CONTRACT CHANGE ORDER NO. ____
SHEET ___ OF ___

MARK	DATE	DESCRIPTIONS	BY	CH'D	CCO#
2	04/05/12	SUSPENSION SYSTEM SHIMS	GB	MN	240
1	04/16/07	CABLE SYSTEM	GB	DT	37

SAN FRANCISCO OAKLAND BAY BRIDGE
EAST SPAN SEISMIC SAFETY PROJECT
SELF-ANCHORED SUSPENSION BRIDGE
(SUPERSTRUCTURE & TOWER)

SUSPENDER BRACKET DETAILS NO. 2

TOWER SADDLE DETAILS NO. 4

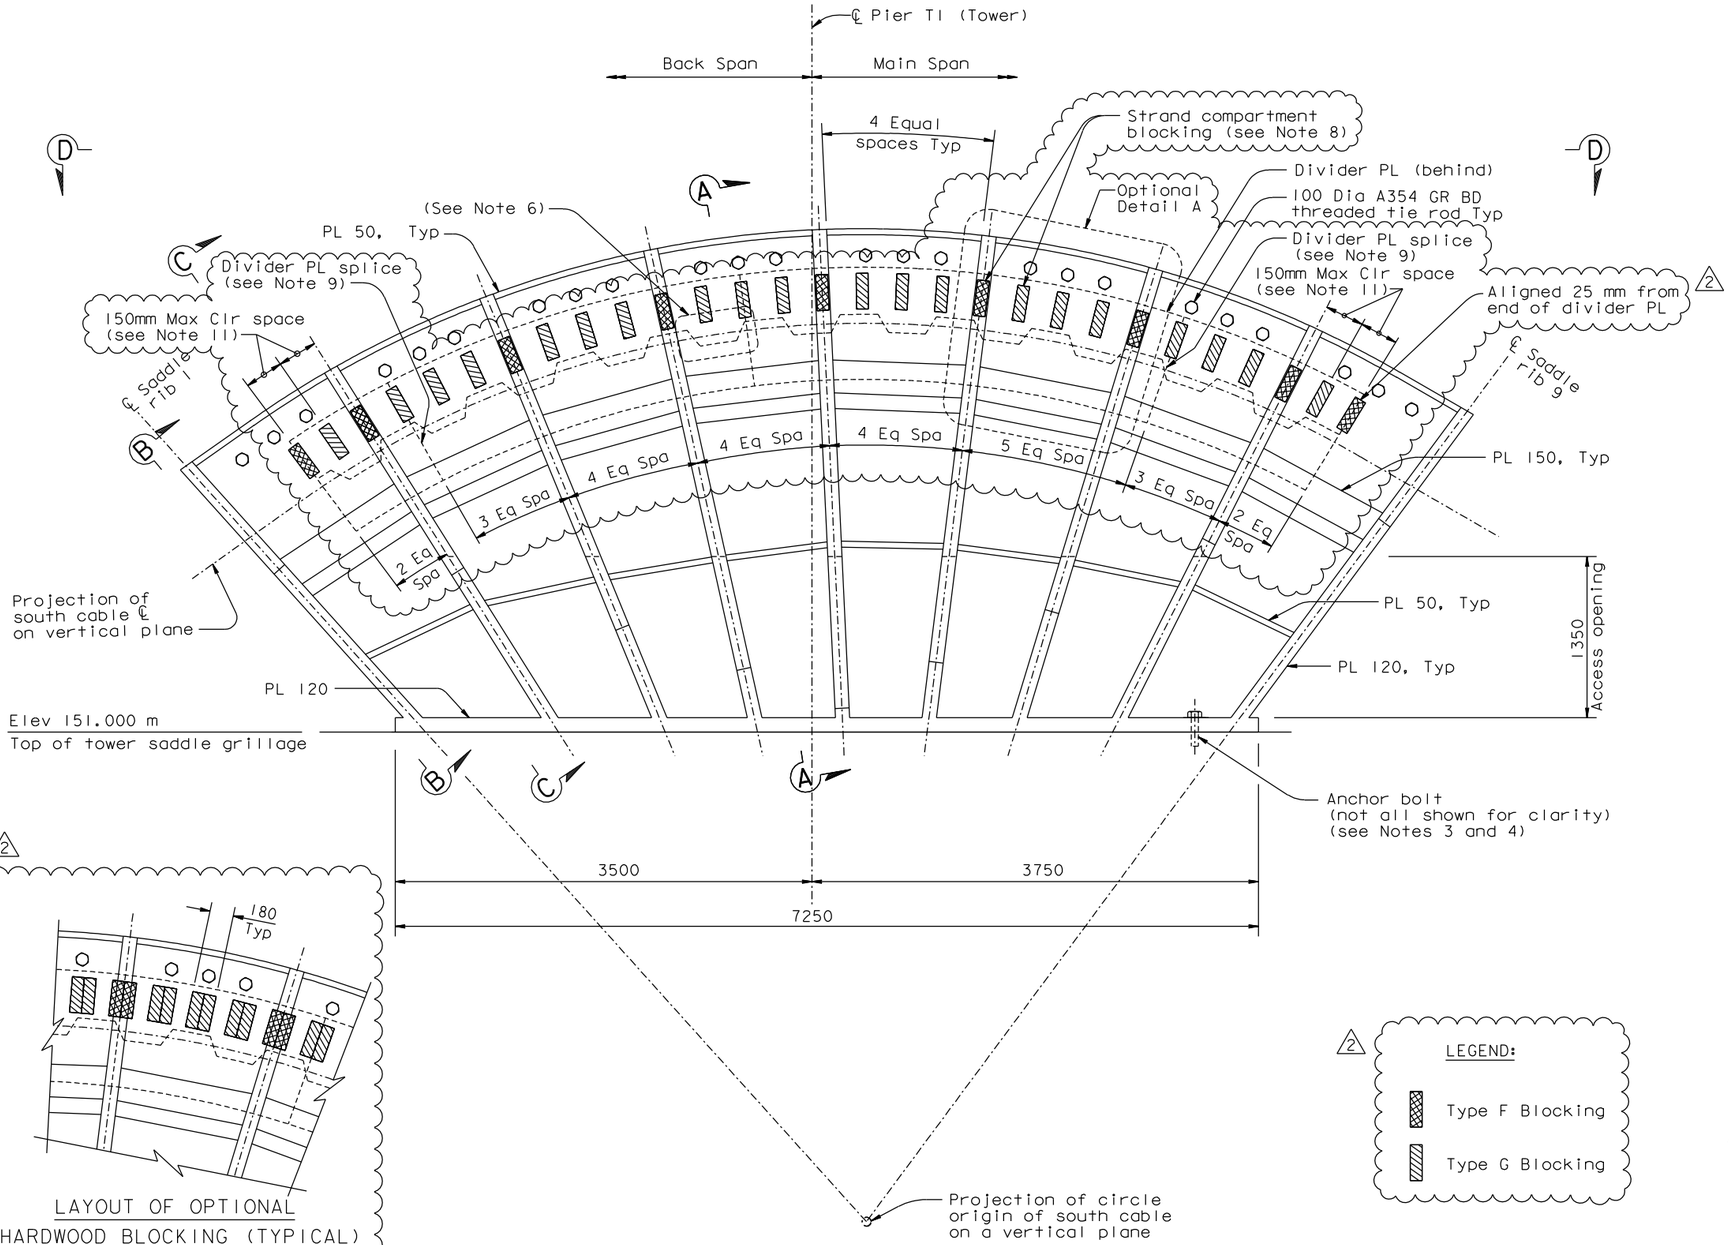
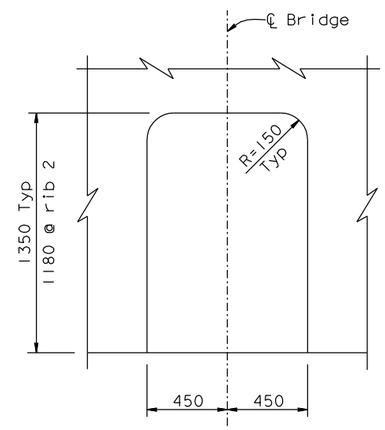
MARK	DATE	DESCRIPTIONS	BY	CH'D	CCO#
2	05/07/12	SADDLE BLOCKING	GB	MN	240
1	10/31/08	TOWER HEAD DETAILS	MN	GB	93

8. Contractor shall fabricate and install new blocking. For layout, see "Tower Saddle Details No.5B" sheet. For blocking details, see "Tower Saddle Details No.6" sheet.

9. The blocking shall be placed such that it straddles the divider plate spacing joint.
10. At the Contractor's option, hardwood blocking may be installed and left in place through load transfer. Hardwood blocking shall be installed in widths of 180 mm, and cut on site to fit tightly at each blocking location. After load transfer, hardwood blocking shall be left in place or replaced as directed by the Engineer.

11. Where clear distance adjacent to G blocking exceeds 150 mm, the Contractor shall install additional 90 mm wide Type G blocking in the space.

TOWER SADDLE DETAILS NO. 5B

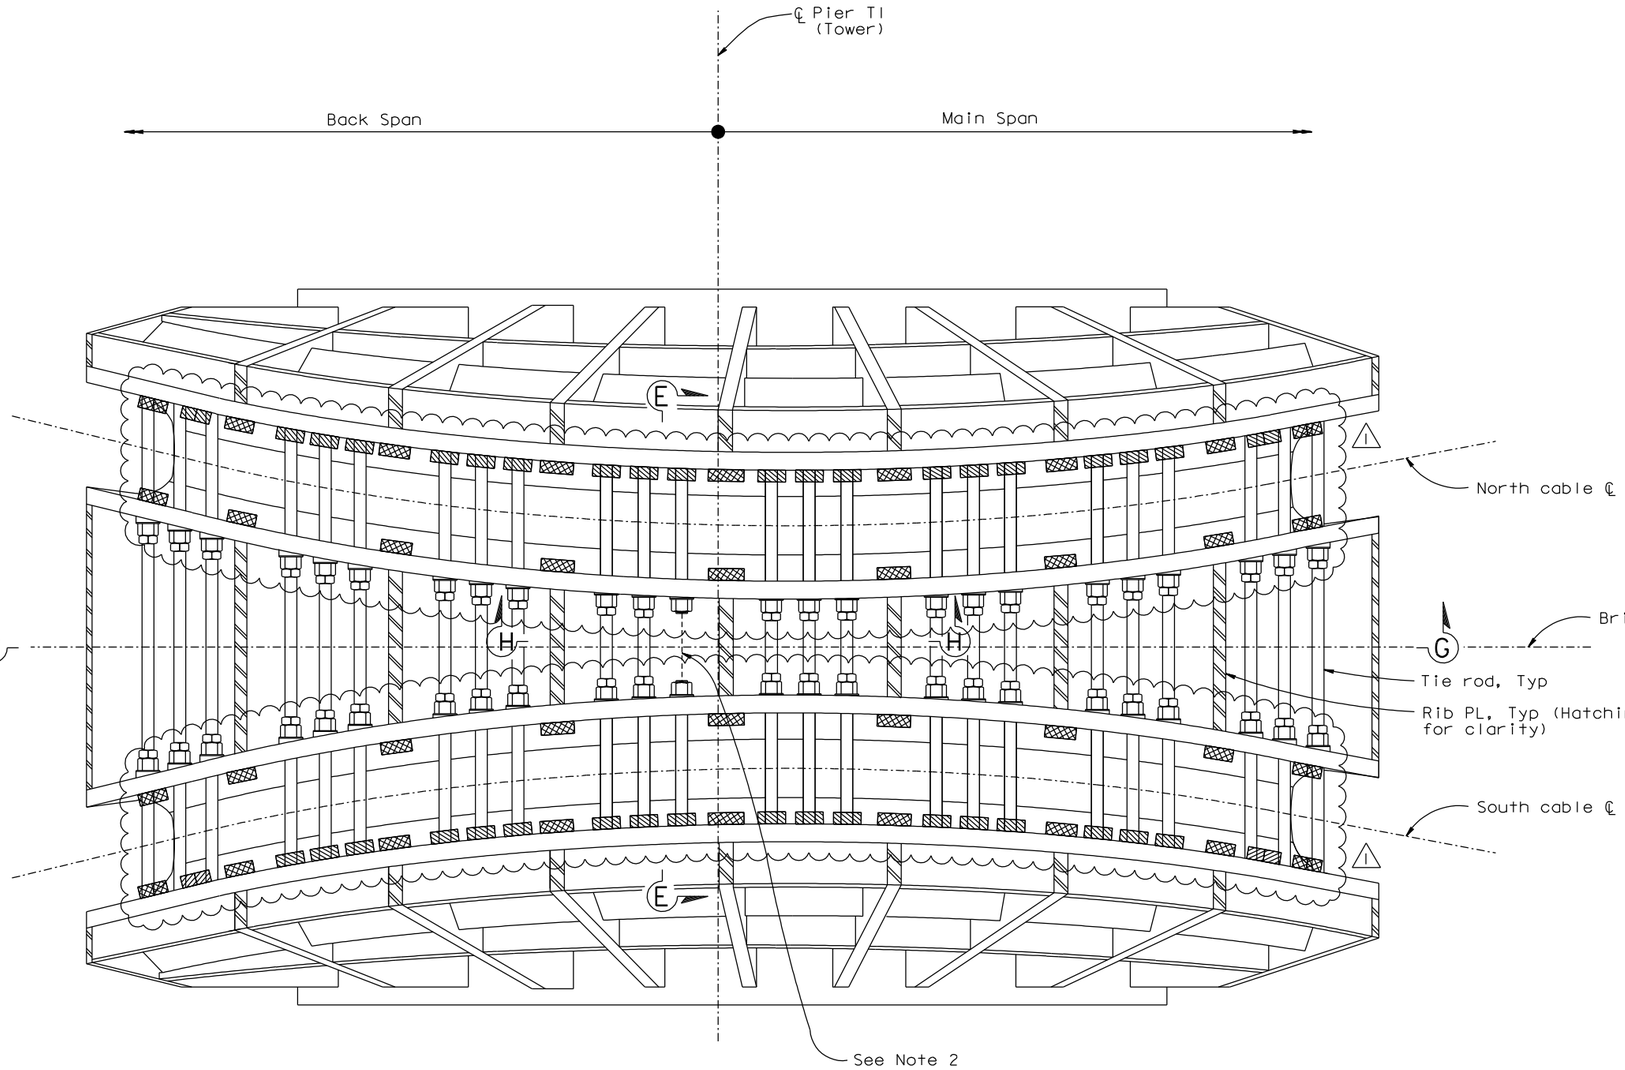
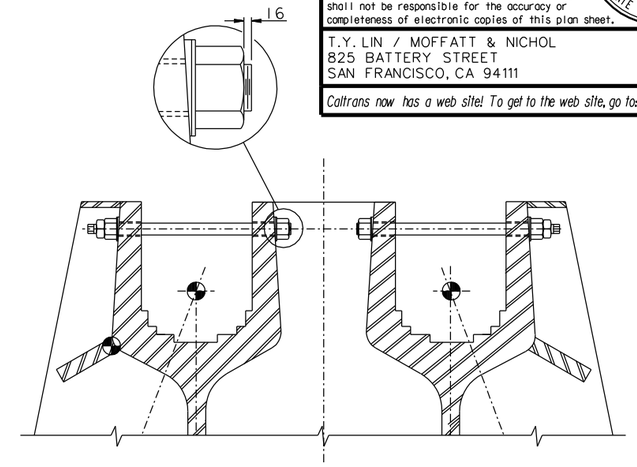
MARK	DATE	DESCRIPTIONS	BY	CH'D	CCO#
1	05/07/12	SADDLE BLOCKING	GB	MN	240
0	10/31/08	TOWER HEAD DETAILS	NV	MN	93

1. For Section G-G, see "Tower Access Details No.23" sheet. For Section H-H, see "Tower Saddle Details No.5A" sheet.
2. Tie rod is discontinuous between saddle troughs at this location only.
3. For blocking, see "Tower Saddle Details No.6" sheet.

TOWER SADDLE DETAILS NO.6

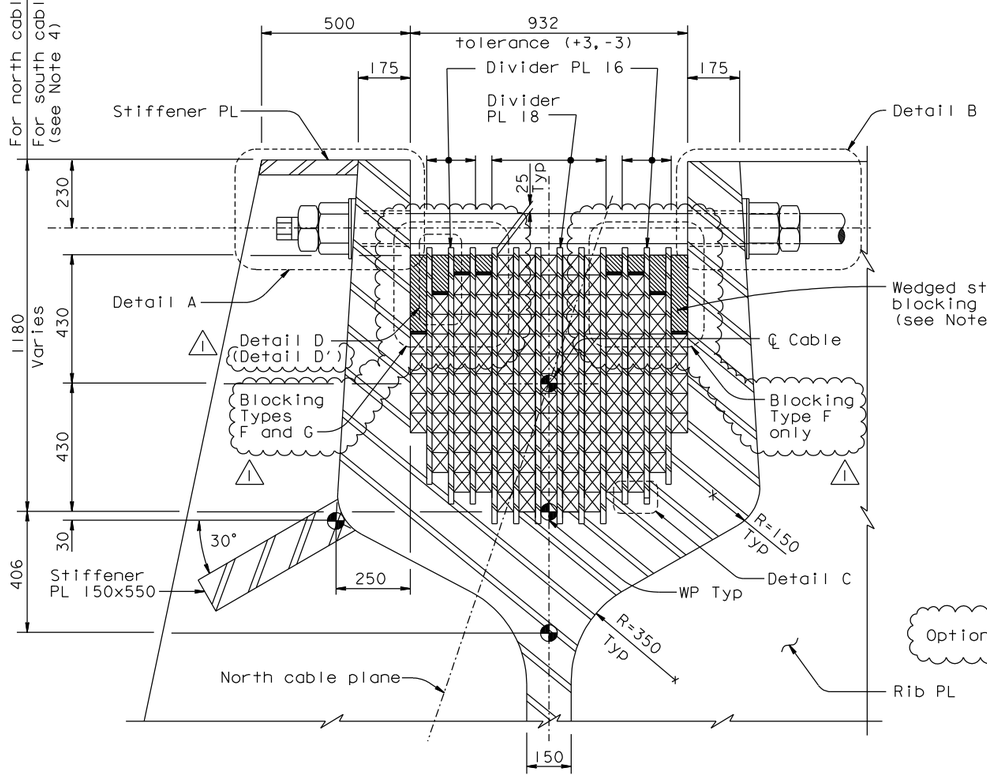
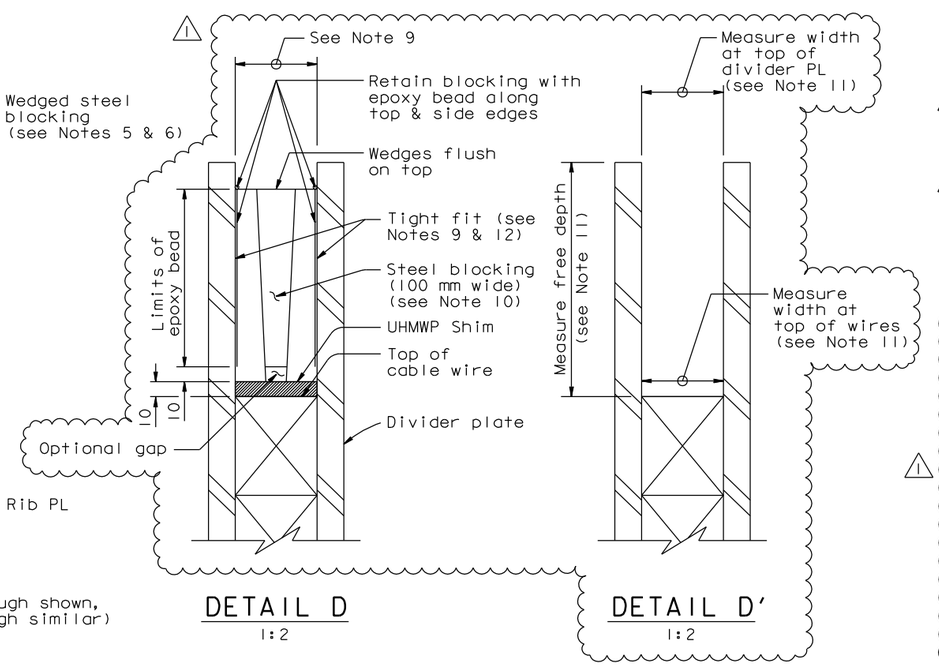
MARK	DATE	DESCRIPTIONS	BY	CH'D	CCO#
1	05/07/12	SADDLE BLOCKING	GB	MN	240

5. Wedged steel blocking layout shall be as shown on "Tower Saddle Details No.5B" sheet. Steel shall be ASTM A572. All surfaces of steel shall be primed.

6. Surfaces of wedged steel plates against the divider plates shall have PTFE film (0.5 mm thick).
7. In lieu of the bevel PL, the Contractor may counterbore the casting up to 12 mm to form a level bearing surface for the nut and washer.

8. The tapered faces of the divider plates shall be placed facing the centerline of the bridge.
9. Prior to fabrication of new blocking, the Contractor shall measure as-built compartment widths. The blocking shall be fabricated to fit tightly at top and bottom within the as-built compartment dimensions.

10. At the Contractor's option, the steel blocking may be fabricated in several pieces. The taper of any piece shall not exceed 1:20. Provide adhesive between surfaces of blocking pieces.

11. Tower Saddle survey (see Detail D'):
    - Measure compartment width at top & bottom
    - Measure compartment depth
    - Measure at each blocking sections Type F & G

- At each section, measure all 13 compartments
12. The completed blocking at each location is fabricated to fit tightly. Should tight fit not be achieved, the Contractor shall inform the Engineer for evaluation.

ELEVATION OF TYPICAL EAST SADDLE (IN THE PLANE OF CABLE) (See Note 6)

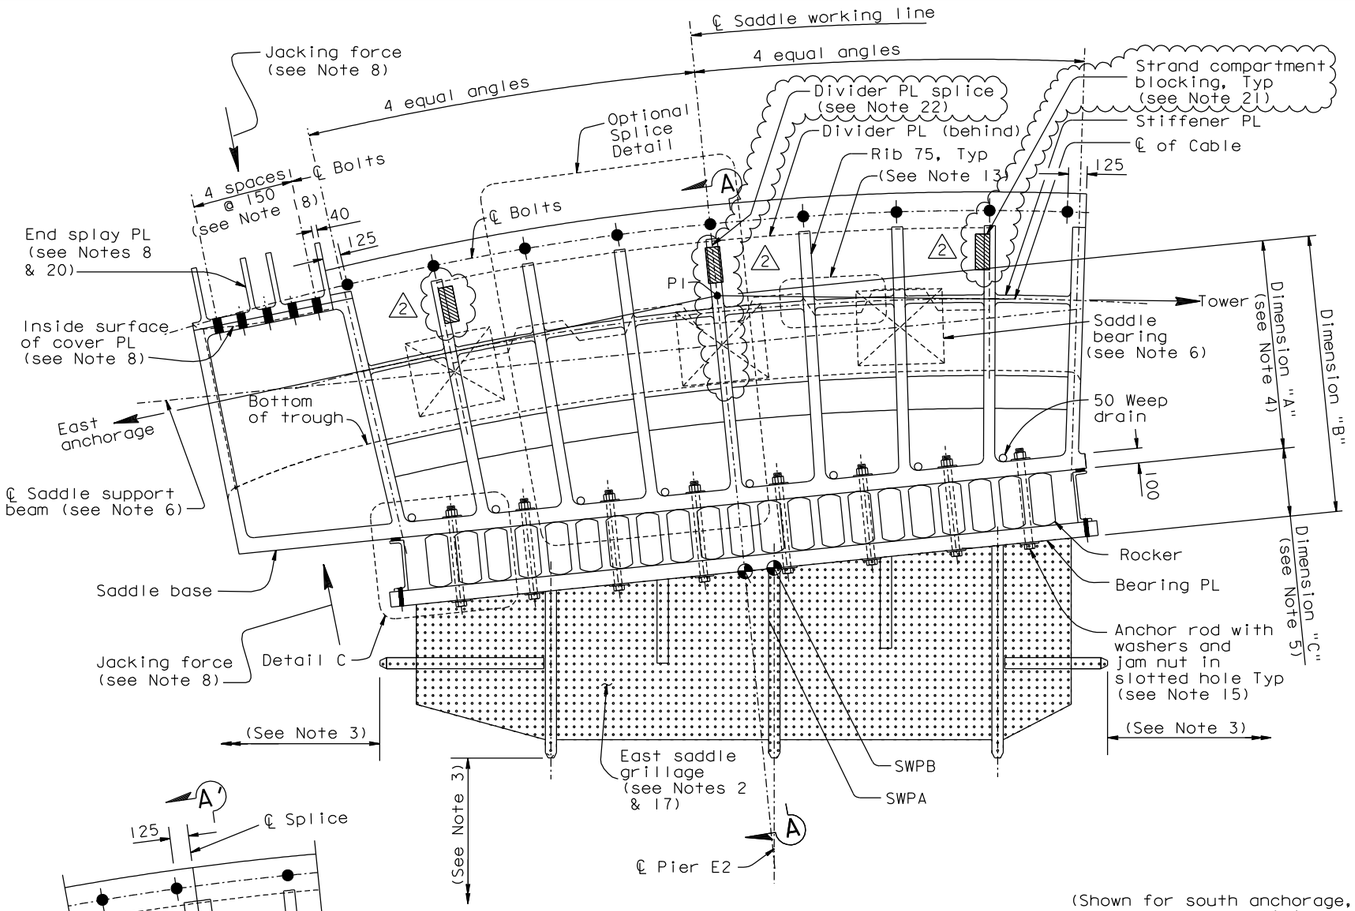
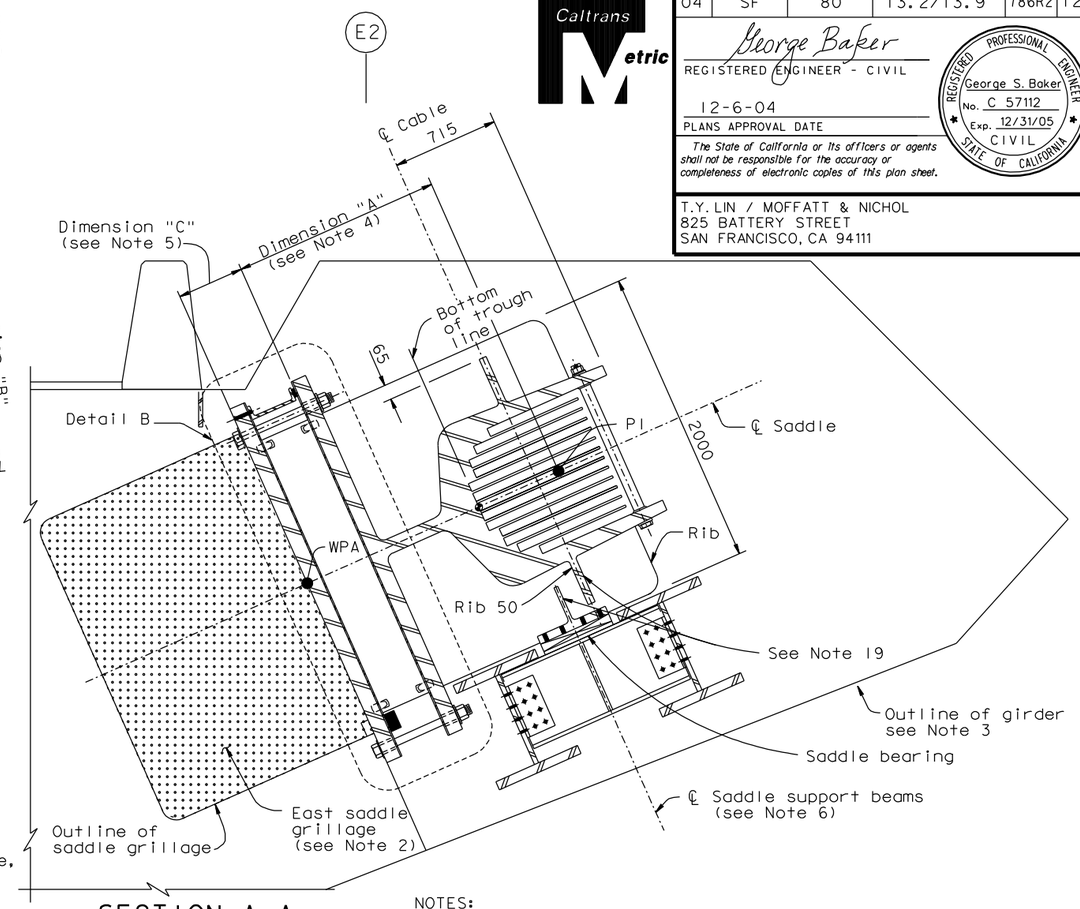
2 21. The Contractor shall fabricate and install new blocking. For typical blocking, see Section A-A on "East Saddle Details No.5" sheet. For typical blocking details, see "East Saddle Details No.5A" sheet.

22. The blocking shall be placed such that it straddles the divider plate splicing joint.

LAYOUT OF OPTIONAL HARDWOOD BLOCKING (See Note 7)

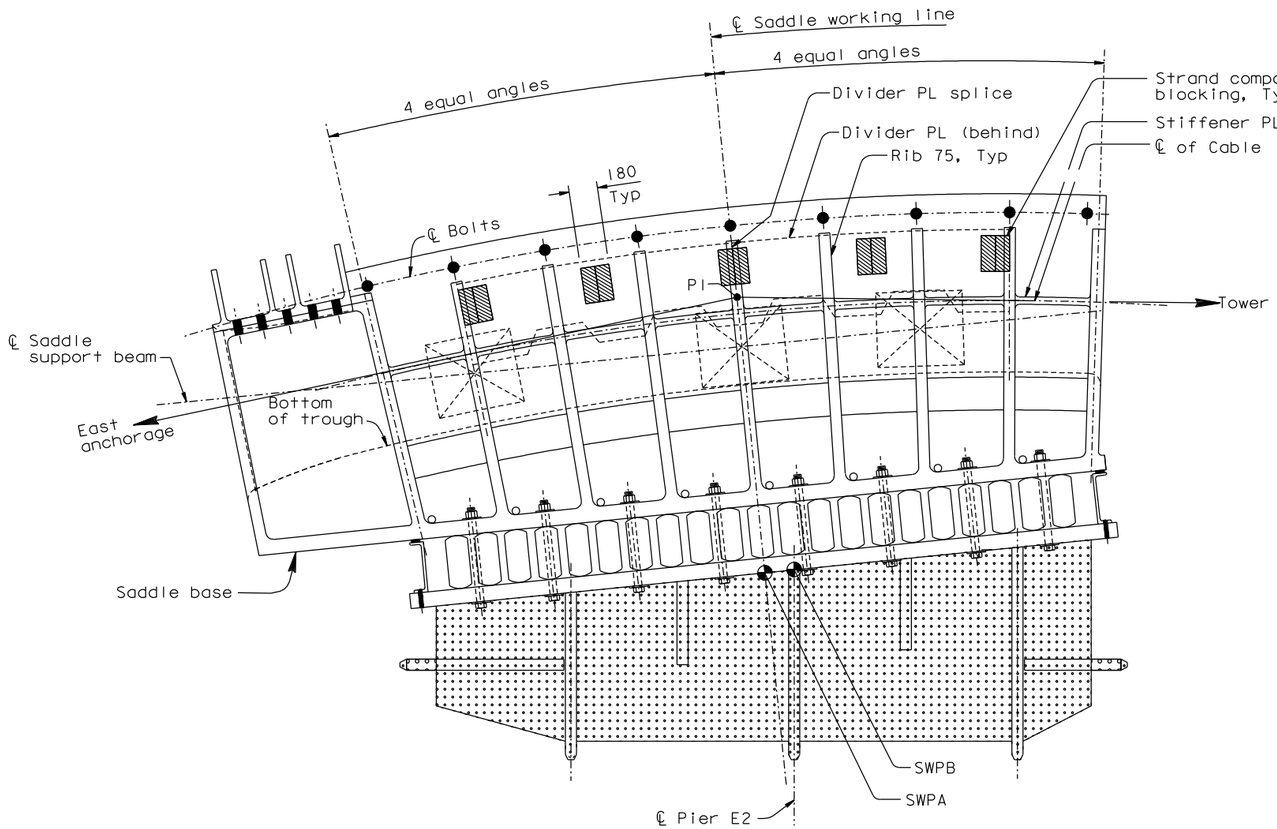
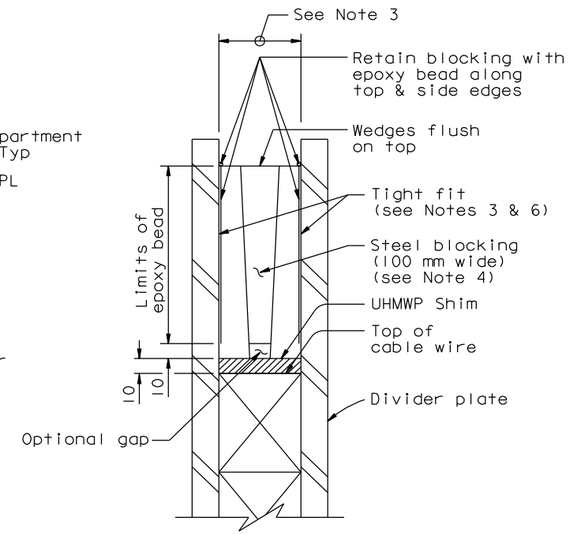
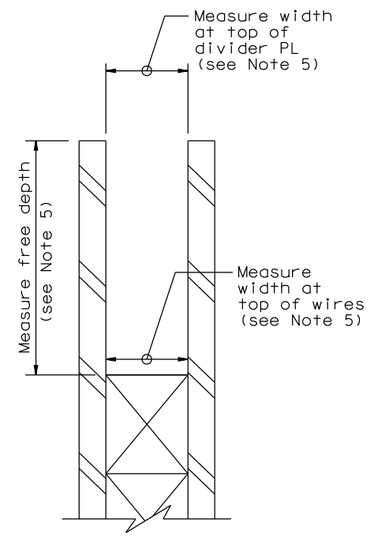
1. Wedged steel blocking layout is shown on "East Saddle Details No. 3" sheet.
2. Steel shall be ASTM A572. Surfaces of wedged steel plates against the divider plates shall have PTFE film (0.5 mm thick). All surfaces of steel shall be primed.

4. At the Contractor's option, the steel blocking may be fabricated in several pieces. The taper of any face shall not exceed 1:20. Provide adhesive between surfaces of blocking pieces.

5. East saddle survey (See Detail D')
   - Measure compartment width @ top and bottom
   - Measure compartment depth
   - Measure @ each blocking section
   - At each section measure all compartments
